IloT Product Change Notice

Change from the old three-hole Din-rail mounting kit to the new five-hole Din-rail mounting kit which can be installed at a variety of angles.

6. The schematic of changes:

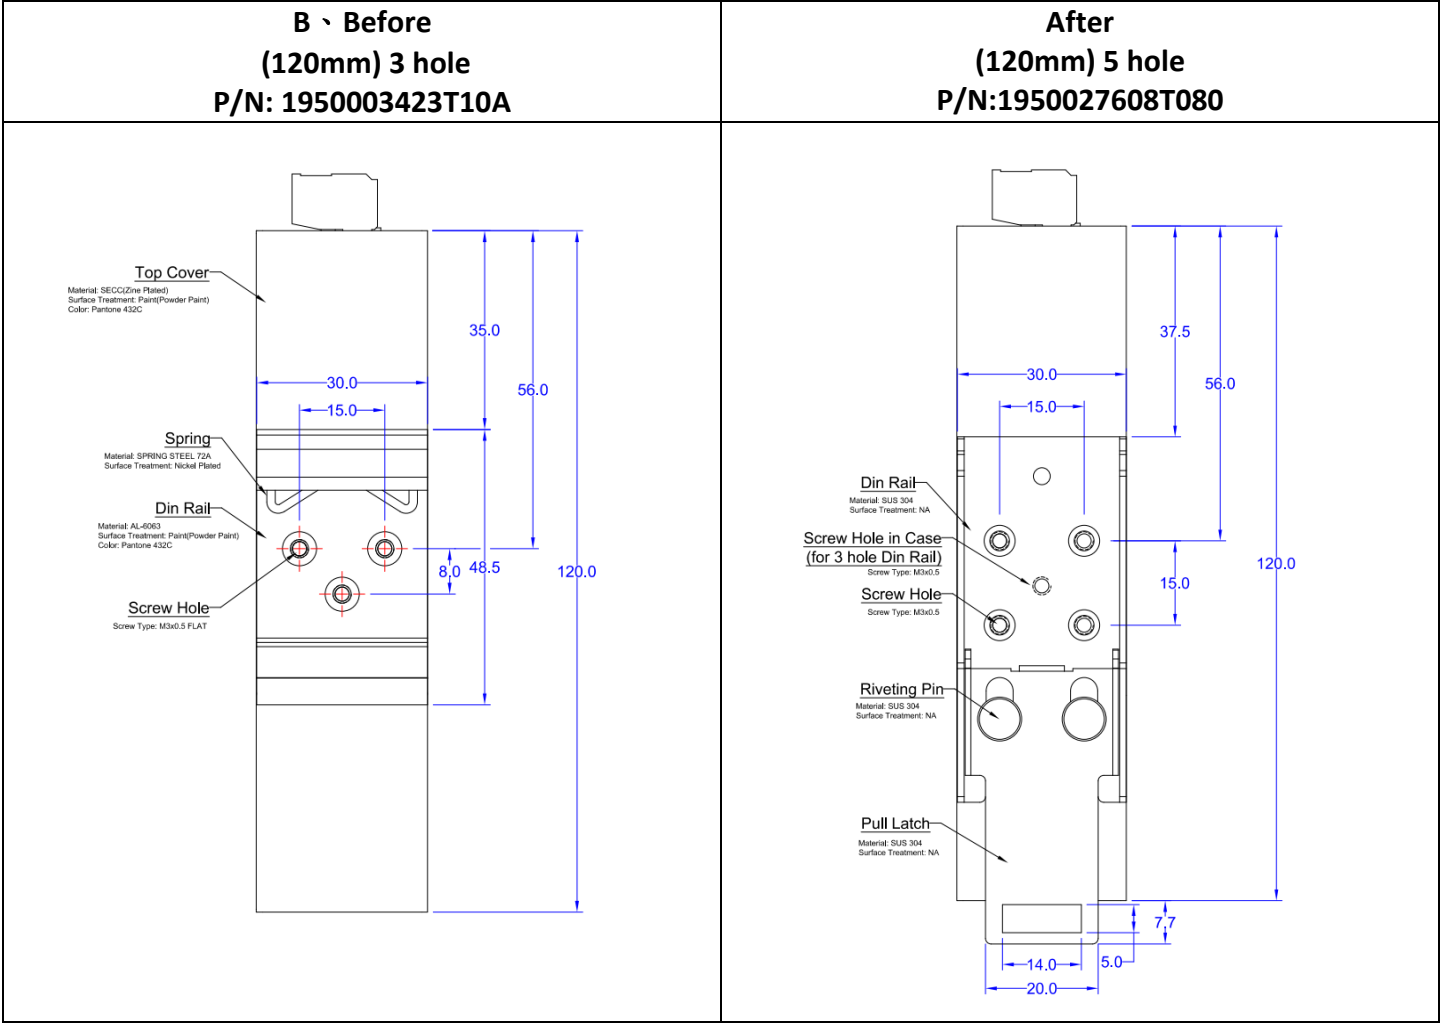
A 、 Before : (140mm) 3 hole P/N: 1950003423T10A	After : (140mm) 5 hole P/N: 1950027608T070
 Top Cover Material: SECC(Zinc Plated) Surface Treatment: Paint(Powder Paint) Color: Pantone 430C Spring Material: SPRING STEEL 72A Surface Treatment: Nickel Plated Din Rail Material: AL-6063 Surface Treatment: Paint(Powder Paint) Color: Pantone 430C Screw Hole Screw Type: M3x0.5 FLAT	 Din Rail Material: SUS 304 Surface Treatment: NA Screw Hole in Case (for 3 hole Din Rail) Screw Type: M3x0.5 Screw Hole Screw Type: M3x0.5 Riveting Pin Material: SUS 304 Surface Treatment: NA Pull Latch Material: SUS 304 Surface Treatment: NA
